Subject ▶ Change on Tension Spring

For Models ▶ LS0810

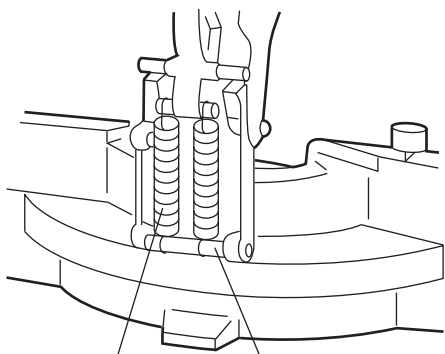
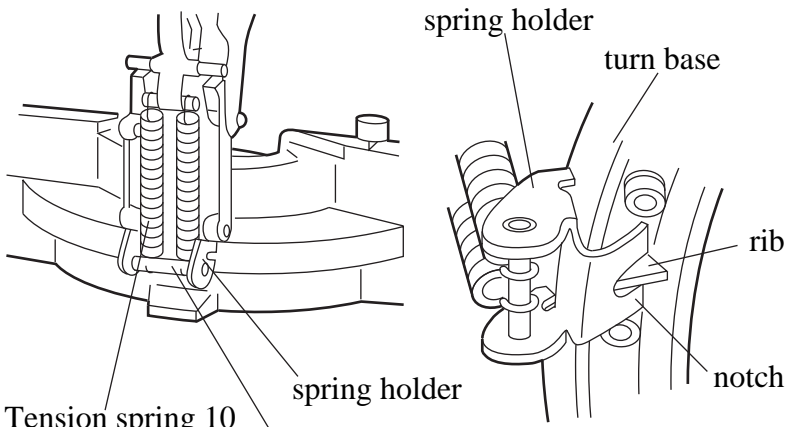
Description ▶ Tension-springs connecting the base and the motor-part have been changed to stronger ones , so that the motor-part can be returned to the original position fully.

▶ Current	▶ New
 <p>Tension spring 9</p> <p>Spring pin 6-55</p>	 <p>Tension spring 10</p> <p>Spring pin 6-40</p> <p>*Spring Holder is to be set as illustrated above:</p>

Item No.	Current part		Q'ty	I/C	New part	Q'ty		Note
59	Tension spring 9 231771-0		2	No	Tension spring 10 231815-6	2		Interchangeable as a set ↑ ↓
97					Spring Holder 344631-8	1		
63	Spring pin 6-55 951234-7		1	=>	Spring pin 6-40 951225-8	1
